Amendments to the Drawings:

REMARKS

FIG.6

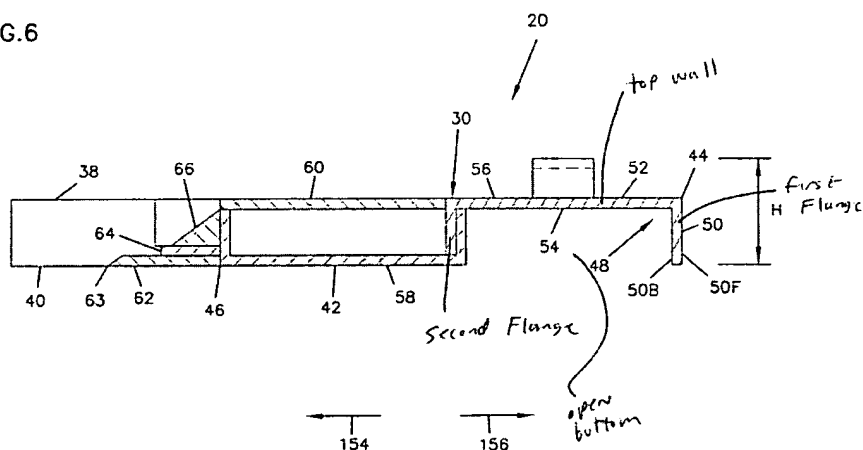
Figures 5 and 6 have been amended to change reference numerals 54 and 56 (corresponding to the direction arrows) to reference numerals 154 and 156. Reference numerals 56 and 60 have also been added to Figure 5 for clarity purposes. The attached Figures 5 and 6 replace all prior versions of Figures 5 and 6.

In the Office Action of April 3, 2006, the Examiner noted that reference characters 54 and 56 have each been used duplicatively. In response, the numbers 54 and 56 corresponding to the direction arrows in Figures 5 and 6 have been changed to reference numbers 154 and 156. Reference numerals 56 and 60 have also been added to Figure 5 for clarity purposes. Approval of the amendments to Figures 5 and 6 is requested.
